ZILBER INDUSTRIAL 3
108th St, Lakeview Corporate Park, Pleasant Prairie, WI
CODE SUMMARY

SUBJECT: Fire Department Review of LakeView 3 Site and Op Plans

These are Comments/Reviews for LakeView 3 Site and Op Plans

PUMPER PAD FDC DETAIL	DETAIL: FD - 1
DATE: 8-19-19	VILLAGE OF PLEASANT PRAIRIE
APPROVED BY: C. ROEPKE	KENOSHA COUNTY, WISCONSIN

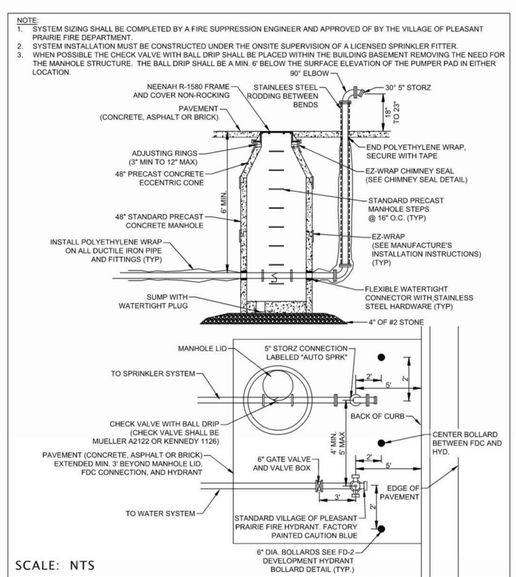
2. The project will require a fire alarm notification and detection system.
3. The FDC/ pumper pad to be located as depicted in the attached markup drawing including a setback as noted.

o. Refer to the Village specification drawing FD-1 for the pumper pad design.
